- 3. Queen Aleta Subdivision
KPB File 2023-015**

Queen Aleta Subdivision

KPB 2023-015

STAFF REPORT

Vicinity Map

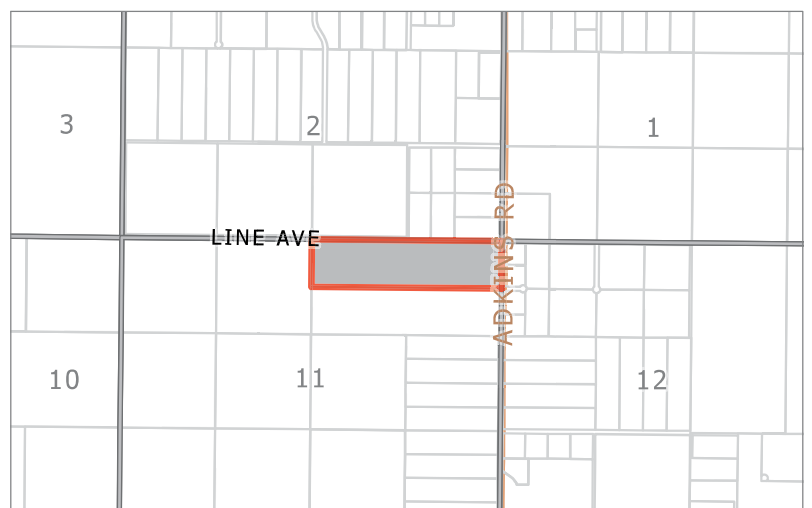
- D. A vicinity map, drawn to scale showing location of proposed subdivision, north arrow if different from plat orientation, township and range, section lines, roads, political boundaries, and prominent natural and manmade features, such as shorelines or streams;
Staff recommendation: *Update the spelling on the lake label.*

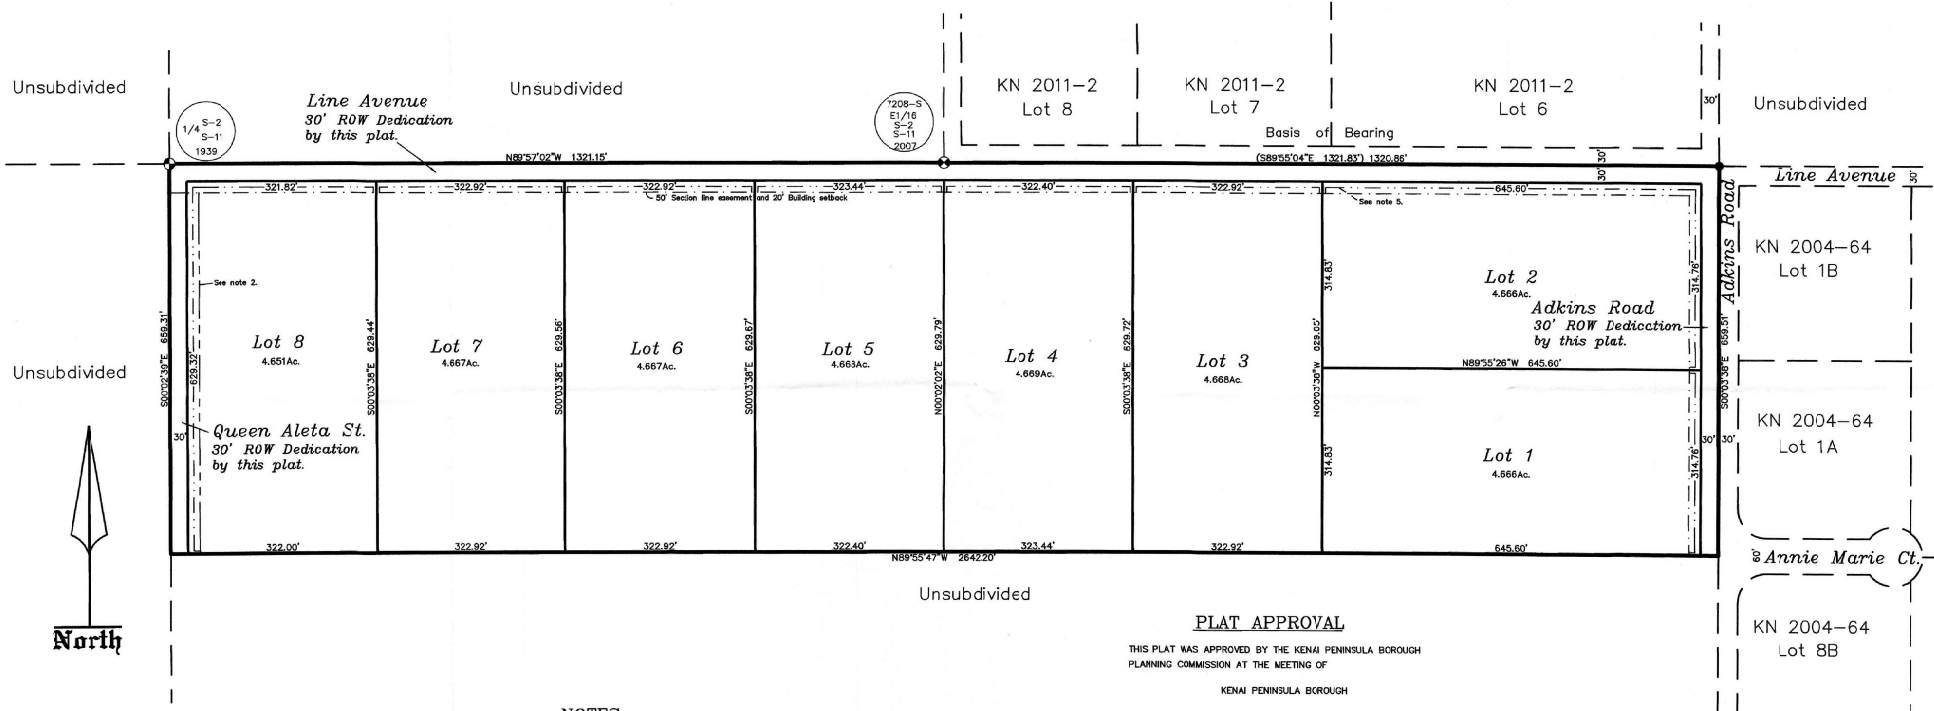
A new dedication is proposed along the western boundary. This is a half dedication with the other half expected from the neighboring property if ever subdivided. The name proposed for the street is Queen Aleta Street. About half a mile to the north is Aleta Avenue off Adkins Road. Due to the proximity and similar name ***staff recommends the street name be shortened to Queen Street.***

Along the western portion of the subdivision there does appear to be some steep slopes present. Some of these steep slopes appear to be within the proposed right-of-way dedications. **Staff recommends centerline profiles and cross-sections be provided for Line Avenue and Queen Aleta Street to determine if additional right-of-way widths or easements are needed. Show the centerline of Line Avenue on the plat drawing.**

Site Investigation: There are no low wet areas within the subdivision boundary. There does appear to be some steep terrain present within the northwest area of the subdivision. Staff is recommending centerline profiles for the proposed dedications due to the terrain. **Staff recommends any steep slopes greater than 20 percent be indicated on the final plat as it may impact development or driveway access.**

- C. The location, width, and name of existing or platted streets and public ways, railroad rights-of-way, and other important features such as section lines or political subdivisions or municipal corporation boundaries abutting the subdivision;
Staff recommendation: *Some road depiction and section line easements will need to be updated before final based on preliminary approved plats in the area. The width of Line Avenue east of Adkins Road needs to be updated as does the eastern half of Adkins Road. Provide a label and width for Coronet Street. If the dedication to the north has not been recorded prior to final, show the section line easement, and show the section line easement along Adkins Road south of the subdivision.*

- F. The location, width and name of existing and platted streets and public ways, railroad rights-of-way, easements, and travel ways existing and proposed, within the subdivision;
Staff recommendation: *Name of Queen Aleta Street may need to be revised.*

- M. Approximate locations of slopes over 20 percent in grade and if contours are shown, the areas of the contours that exceed 20 percent grade shall be clearly labeled as such;
Staff recommendation: *Contours were not shown. Reminder that failure to present such information may delay the scheduling of an item for a meeting as the application will be viewed as incomplete. Northwest corner has steep areas that need to be identified.*

- 20.30.160. Streets-Name requirements. Streets shall be named to conform to KPB Chapter 14.10
Staff recommendation: *Aleta Avenue is located to the north of this subdivision. It is advised to remove Aleta from the name and staff recommends “Queen Street”.*

Correct plate note 4 by adding the reference to KPB Code 14.06.

As plat note 6 states that all wastewater systems need to comply with DEC requirements, plat note 3 is not required.

- "Subject to a right-of-way granted to Alaska Pipeline Company per BLM Serial No. A-051647 that is 25 feet from centerline as stated within State of Alaska Patent 7657."
- Subject to a right-of-way permit granted to Homer Electric Association, Inc. by ADL 51477 for an electrical distribution line, 20 feet on centerline as stated within State of Alaska Patent 7657."
